## SERVICE KIT 753-0535

ST-098

Plastic Chute Adapter on

Snow Throwers

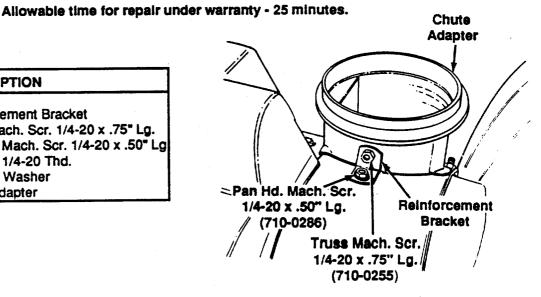
Reports from the field indicate that on some models 312-610E, 640F and 660G000 Snow Throwers that the

plastic chute adapter part number 731-1306 is breaking.

Part was found to be made from inferior plastic.

Install Service Kit 753-0535. Kit contains improved chute adapter and a reinforcement bracket with hardware.

1. Remove chute crank bracket and lower chute from broken chute adapter.

2. Remove broken chute adapter from housing, replace with new adapter.

NOTE: When installing new adapter make certain lip of adapter is seated into blower housing.

- 3. Place reinforcement bracket provided in kit against new chute adapter and blower housing near center of adapter as shown.
- 4. Mark hole locations in housing and adapter with a marker and drill two 9/32" holes for mounting the bracket.
- 5. Install one 1/4-20 x.50" lg. machine screw provided in kit through housing and reinforcement bracket and secure with bowed washer and nut as shown. Install the remaining 1/4-20 x .75" lg. machine screw through new chute adapter and reinforcement bracket and secure with bowed washer and nut provided.
- 6. Reassemble chute crank bracket and lower chute to new chute adapter.
